ENGINEERING CHANGE NOTICE NO. 07031  JAMES NO. 645.6500  REV: B TO C PREPARED K. TAILOR  DATE: 04-19-23  POR 11TLE: PUNCTURE DISC RETAINER  APPROVED BY: NOR PROVIDED INC.  REASON: REVISED TEMPLATE AND VIEWS FOR CLARITY. REVISED NEIS. REVISED HEX KEYWAY. ADDED CHAMFER TO THREAD. ADDED CHAMFER AND RADII (FOR MACHINING) AS REQUIRED.  SHEET 1. NOTES WAS:  NOTES:  1. DEBURR AND BREAK ALL SHARP EDGES  2. MATERIAL: STAINLESS STEEL 303 IAW AMS-5640  3. IDENTIFY IAW MPP-120  4. FLAT SAND AFTER TUMBLE DEBURR	RELEASE DATE 2023.06.28 - R	EF ECR 1547							
AEROSPACE APPROVED BY:  DWG TITLE: PUNCTURE DISC RETAINER  APPROVED BY:  PART AEROSPACE APPROVED BY:  P			CHANGE N	OTICE NO.	0	7031	SHEET	1 OF 3	
APROVED BY:  BY UNCTURE DISC RETAINER  APPROVED BY:  BY UNCTURE DISC RETAINER  CASE NUMBER:  REASON CODE  MDI  TRANSACTION CODES (TC).  REASON:  REASON:  REASON:  REASON:  REASON:  CHAMFER TO THREAD. ADDED CHAMFER AND RADII (FOR MACHINING) AS REQUIRED.  SHEET 1, NOTES WAS:  NOTES:  1. DEBURR AND BREAK ALL SHARP EDGES  APPROVED BY:  MATERIAL: STAINLESS STEEL 303 IAW AMS-5640  3. IDENTIFY IAW MPP-120  4. FLAT SAND AFTER TUMBLE DEBURR	DARI	DWG NO.	645.6500	REV: B	OC PREPARED K. TA	AILOR DATE:	04-19-23

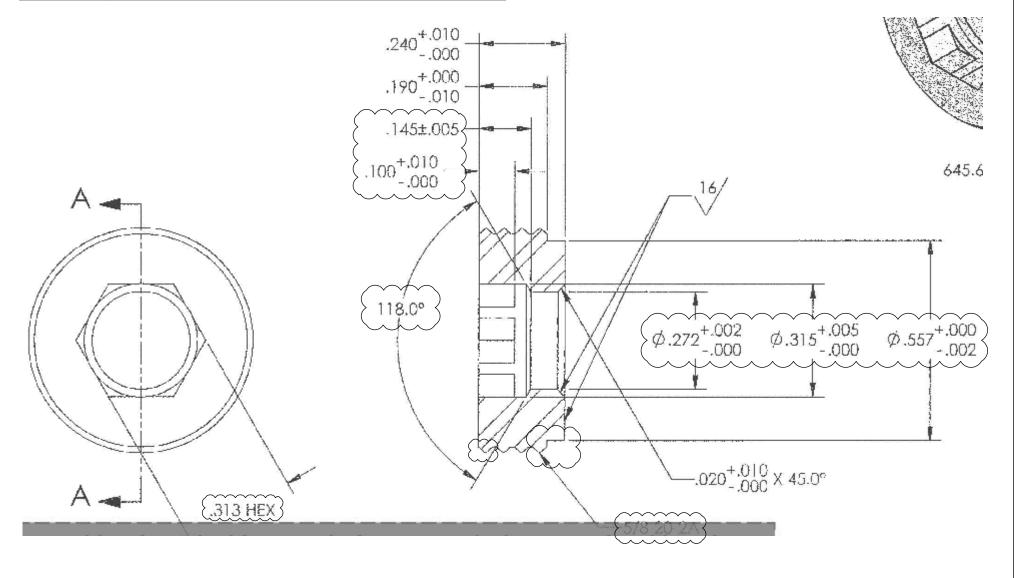
DART AEROSPACE  IRANSCIION CODES (IC):  REASON: REVISED IEMPLATE AND VIEWS FOR CLARITY. REVISED NOTES. REVISED HEX KEYWAY. ADDED CHAMFER TO THREAD. ADDED CHAMFER AND RADII (FOR MACHINING) AS REQUIRED.  SHEET 1. NOTES WAS:  NOTES:  1. DEBURR AND BREAK ALL SHARP EDGES  2. MATERIAL: STAINLESS STEEL 303 IAW AMS-5640  3. IDENTIFY IAW MPP-120  4. FLAT SAND AFTER TUMBLE DEBURR		DWG TITLE: PUNCTURE DISC RETAINER
